ONSITE SEWAGE DISPOSAL SYSTEM

PROPERTY ADDRESS: 13471 Triadelphia Mill Road

APPLICATION FOR VARIANCE

LETTER OF TRANSMITTAL

PRE-CONSTRUCTION:

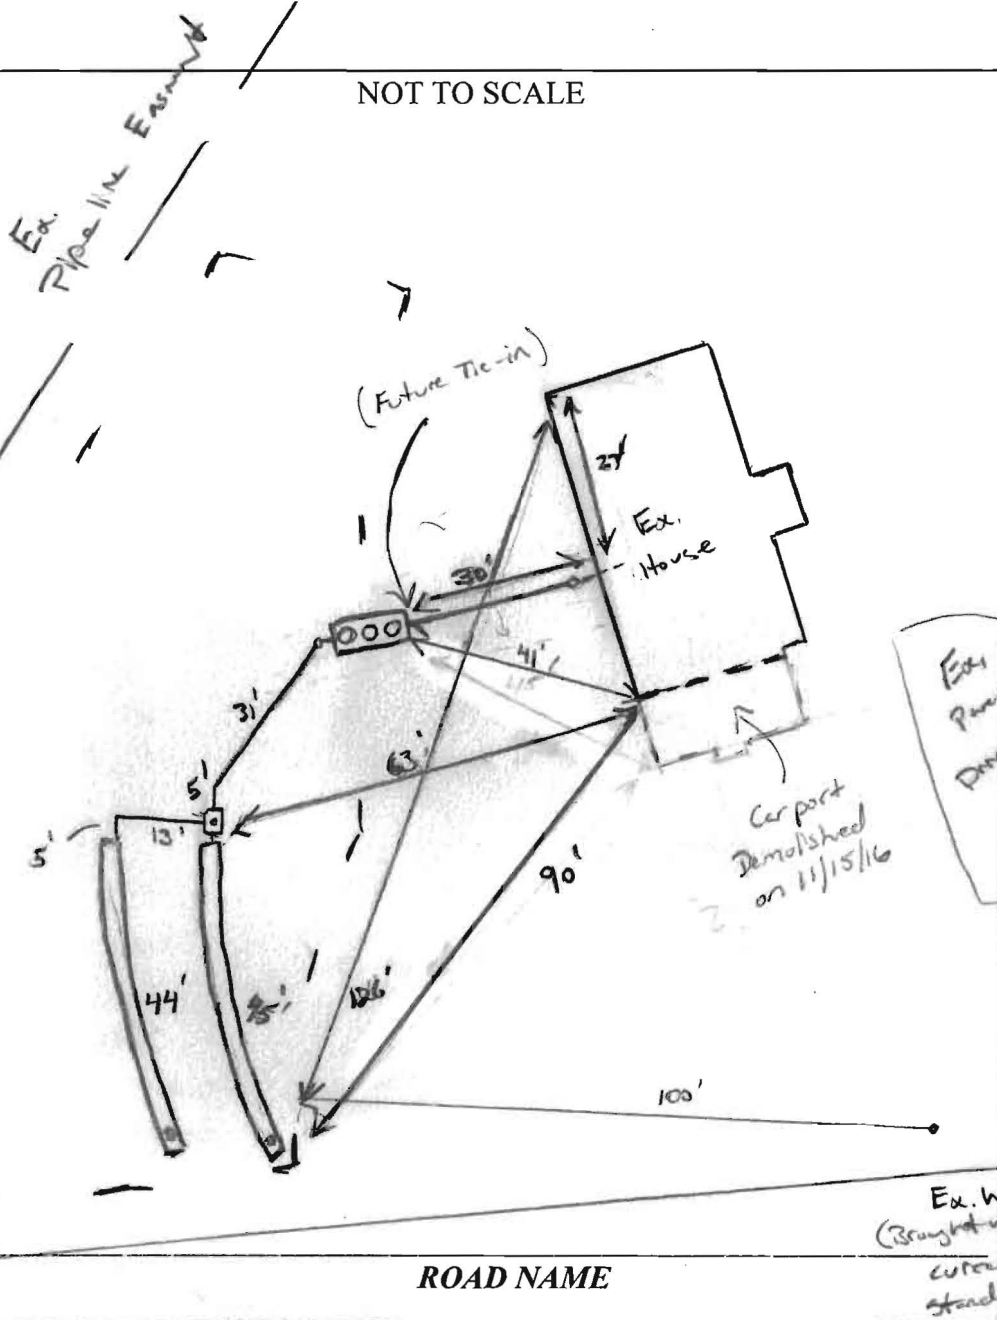
11/2/16 Met w/ contractor on-site. Laid out 2 x 44' trenches close to approved BAT site plan. Owner and contractor asked to turn BAT unit and move slightly downhill in SOA. 'OK'. Call for inspection. (Kw)
 Also Contractor to install new plumbing from ex. house to BAT.

11/14/16 BAT unit set. Lower trench complete. Upper trench 75% complete. OK. to continue.
 11/15/16 Dbox set, all plumbing installed. Dbox to be leveled by homeowner w/ speedy leveler. (Owner is a master plumber). System complete. OK to back fill. Need BAT start-up approval for permit approvals (Kw) 11/21/16 Start-up cards rec'd but no power to BAT or house yet. (Kw) 6/27/17 Still no power to BAT. Need plastic screw caps on cleanouts 7/13/2017 BAT Has power and
 Screws cap. on obs ports.

PLAN VIEW

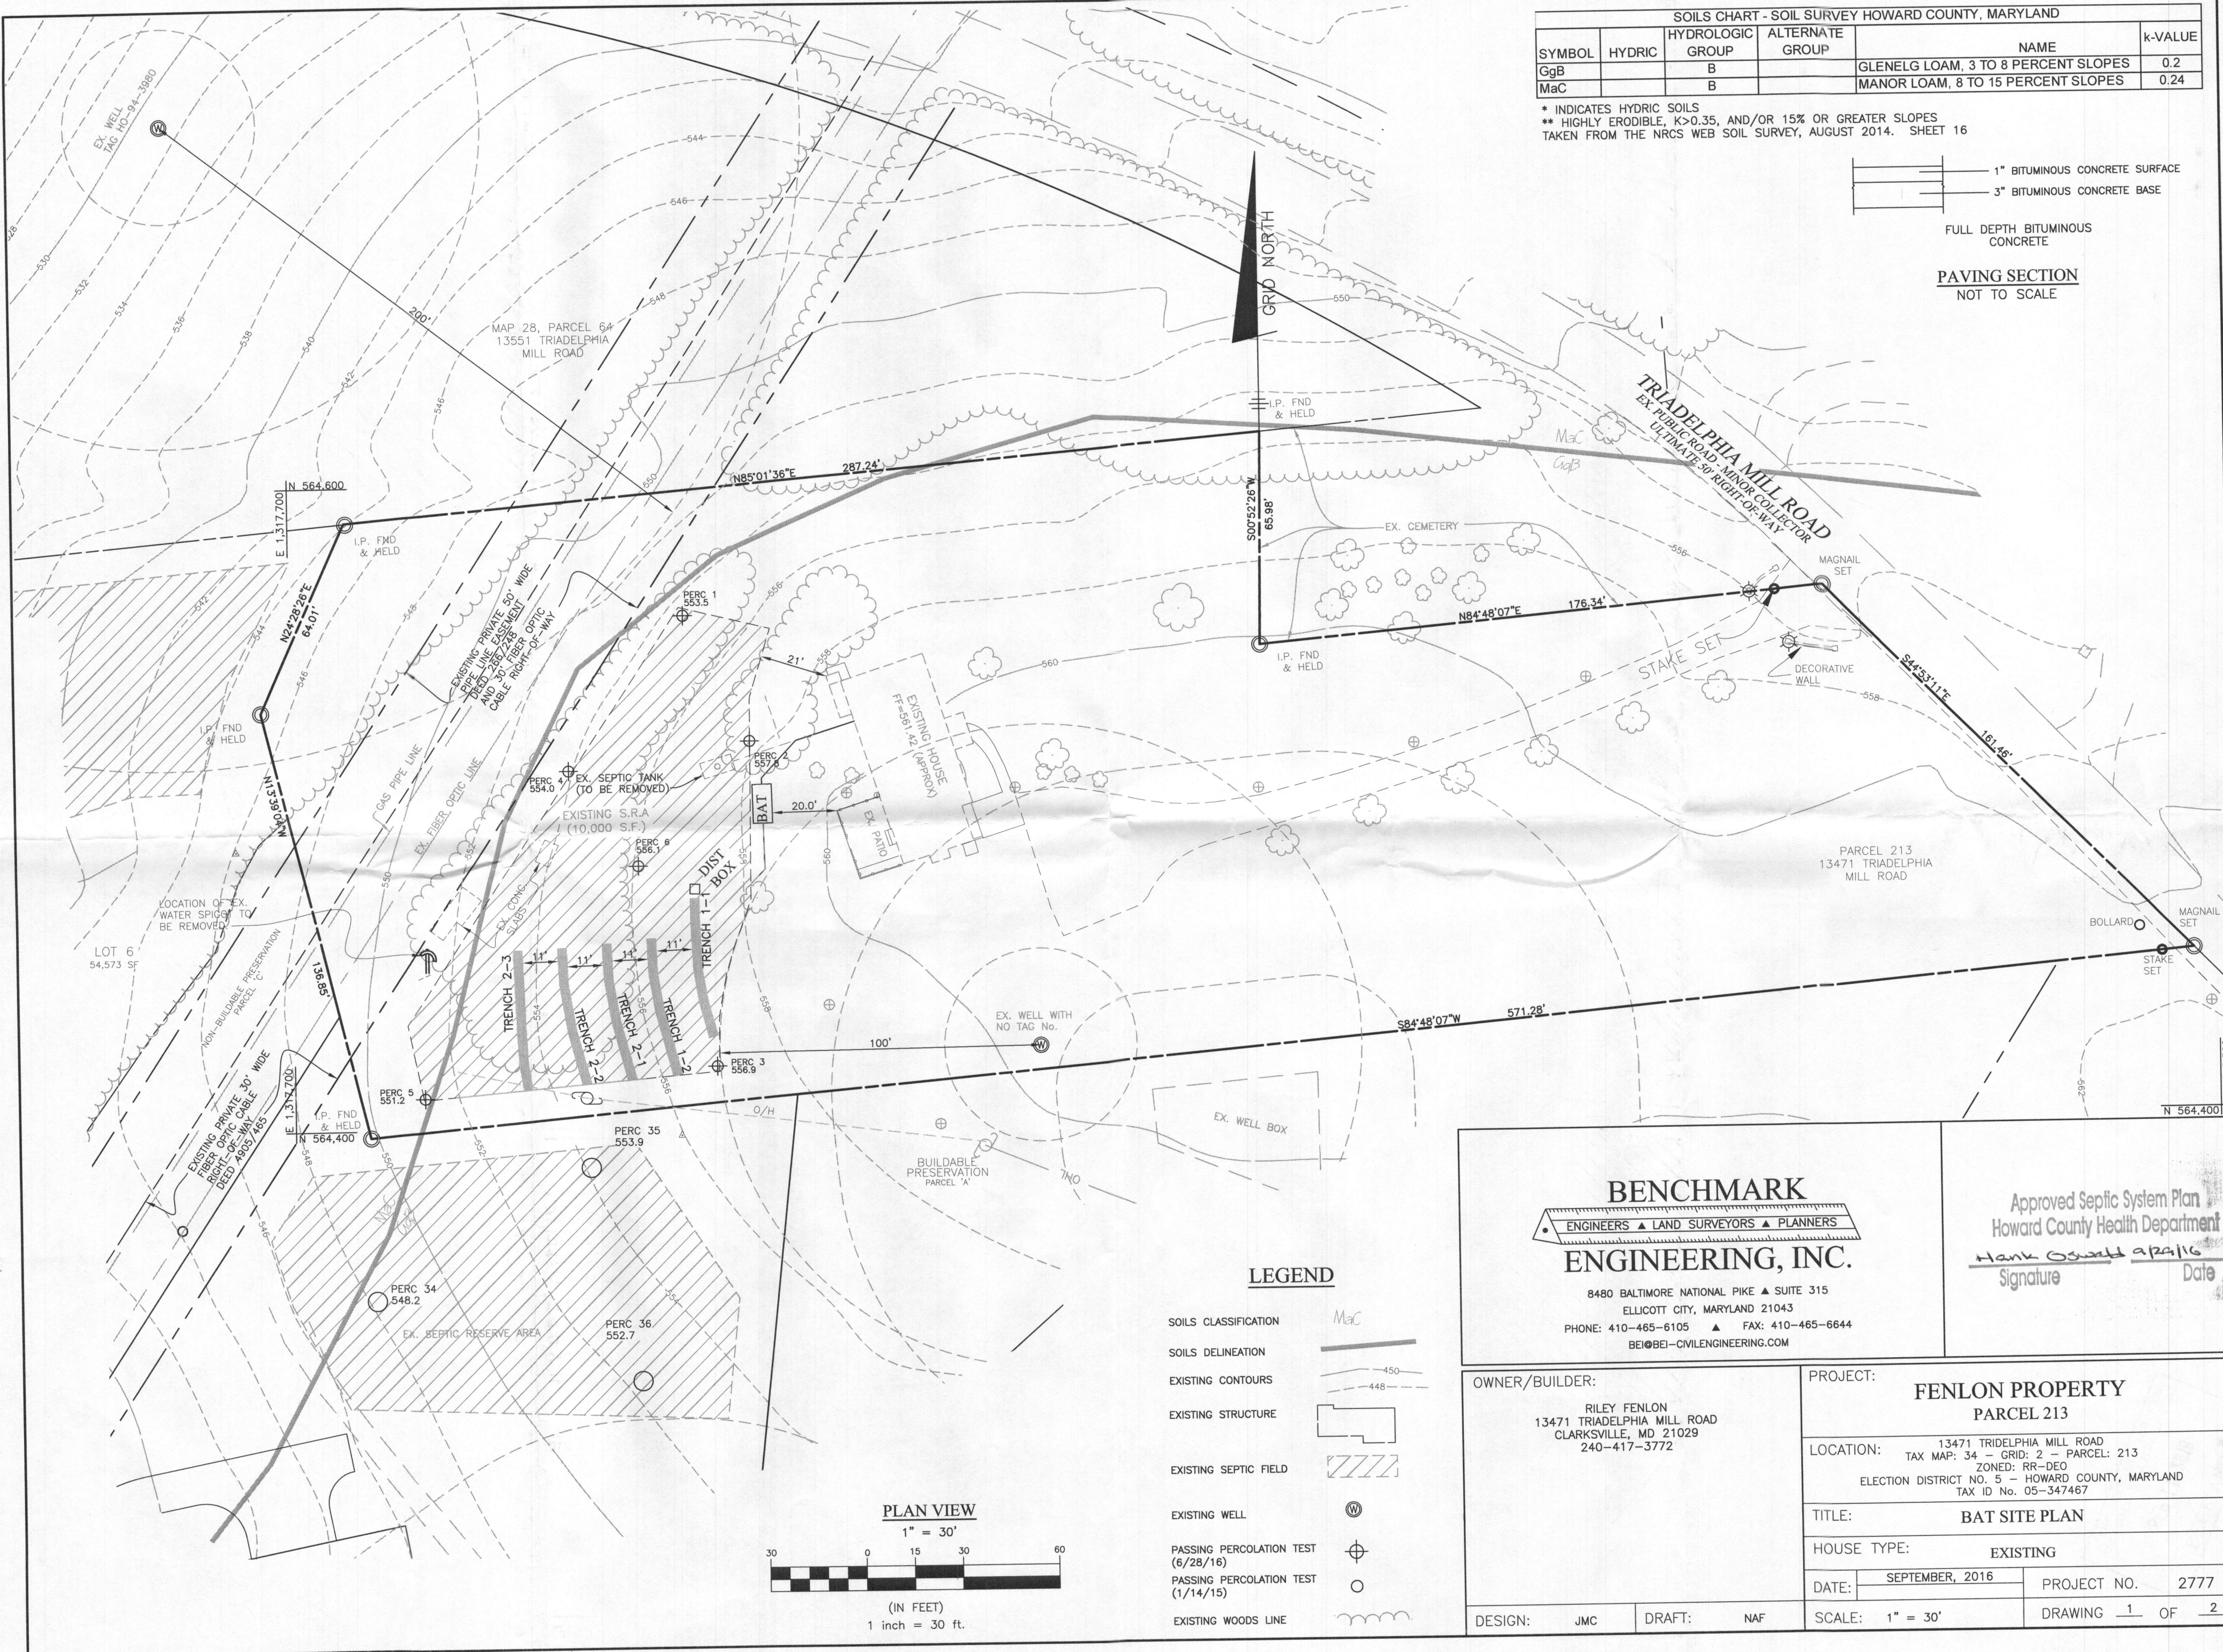
The first trench is slightly within the well arc. I would pull it down a bit. Also, reposition the d-box in front of trench 1.
